**Re: *Kennecott Eagle Minerals Company ("KEMC");
Marquette, Michigan;
Underground Injection Wells***

Memorandum

Subject: Response to Kennecott Eagle Minerals Company's April 28, 2009 Letter to the U.S. Environmental Protection Agency, Region 5, Re: Response to March 13, 2009 Request for Inventory and Other Information Concerning Proposed Kennecott Eagle Mine

Figure 1. KEMC's conceptual flow model. Note: KEMC's conceptual flow model is based on available information provided in Foth & Van Dyke and Associates, 2006b.

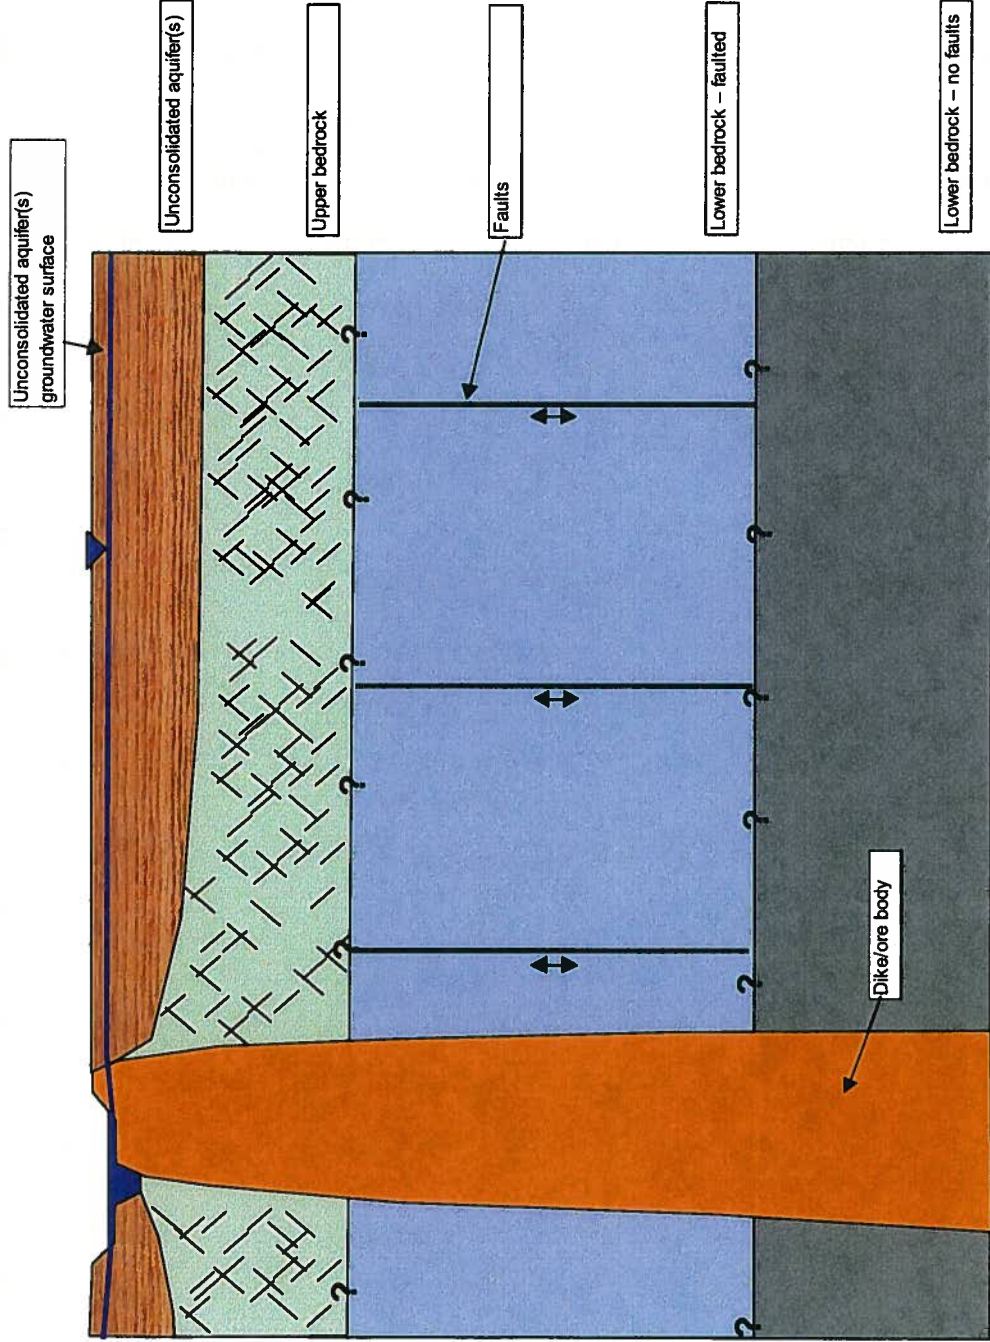
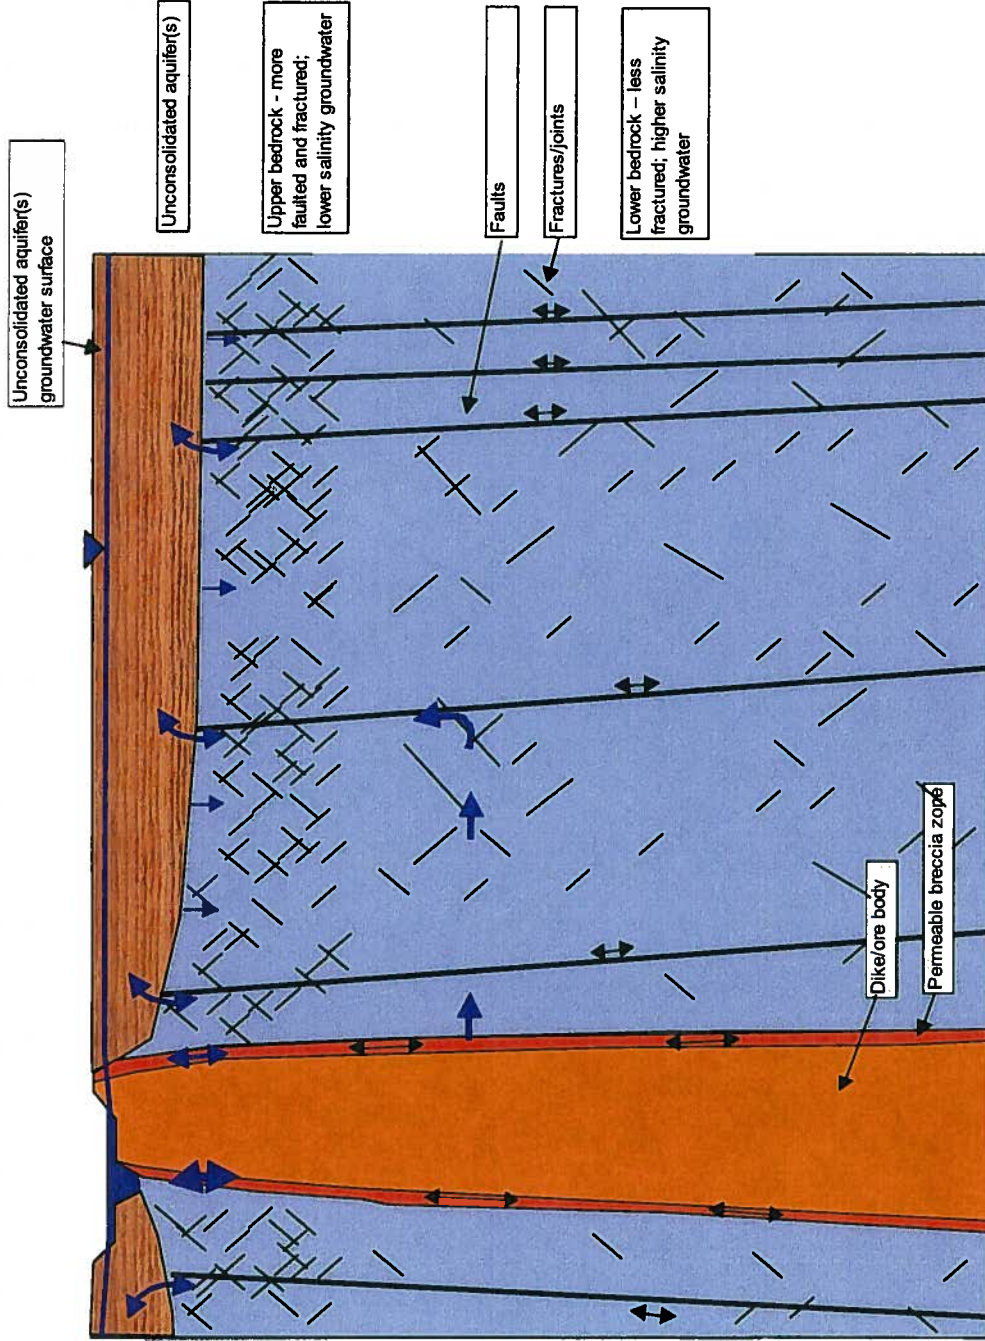
There are notable differences between KEMC's and KBIC's conceptualizations of flow in the bedrock aquifer and flows between the bedrock and overlying unconsolidated aquifers and the Salmon-Trout River. The differences are summarized in Figures 1 and 2. KEMC's conceptual model is shown in Figure 1. In their conceptualization, the upper and lower bedrock have major hydrogeologic and structural differences. For example, KEMC believes that faults exist only in the lower bedrock and do not extend into the upper bedrock, and fractures and joints exist only in the upper bedrock zone. The edge of the peridotite dike/ore body is not noted as being permeable or highly fractured, and flows to and from the unconsolidated glacial aquifer are not noted. In KBIC's conceptual model (Figure 2), there is no difference in rock type and no structural feature or unconformity that define the differences between the two bedrock zones. The faults extend through both the upper and the lower zones of the bedrock aquifer, and enhanced vertical flow is shown along the fractured brecciated edge of the dike/ore body. Fractures and joints are shown in both the upper and the lower zones, and the zones are part of a hydrologically connected bedrock aquifer.

Based on the existing information, including information from KEMC's geologists, we continue to believe that the bedrock and glacial aquifers and the Salmon-Trout River act as an interconnected hydrologic system. The bedrock aquifer is hydrologically linked to the unconsolidated aquifer, which is also a USDW. As a result of these hydrologic connections through faults and fractures, dewatering and mining activities in the bedrock aquifer will affect water quality and quantity in the overlying USDW unconsolidated aquifer. In addition, the bedrock aquifer is very likely in direct hydraulic communication with the Salmon-Trout River. In fact, KEMC's drawings have indicated this (see, for example, Foth & Van Dyke and Associates, 2006a, Appendix B-8, Figure 21). As a result, mining and dewatering operations in the bedrock will affect flows and water levels in the Salmon-Trout River, the overlying wetlands, and the glacial aquifer, and water from the unconsolidated aquifer and the Salmon-Trout River will strongly influence mine inflow rates.

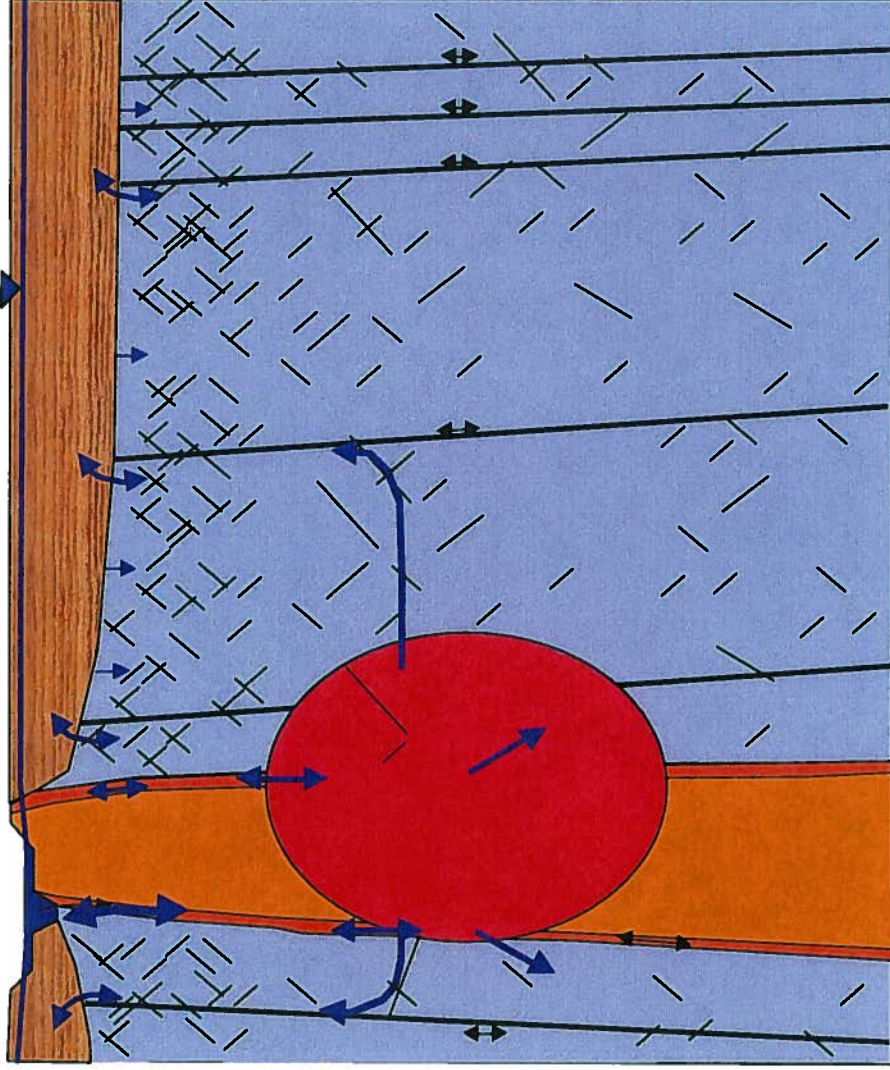
KEMC's conceptual model predicts that water in the underground mine will not move at all after groundwater levels are re-established. KBIC's conceptual model predicts, more realistically, that water will flow downgradient and contaminate the USDW after mining ceases (Figure 3).
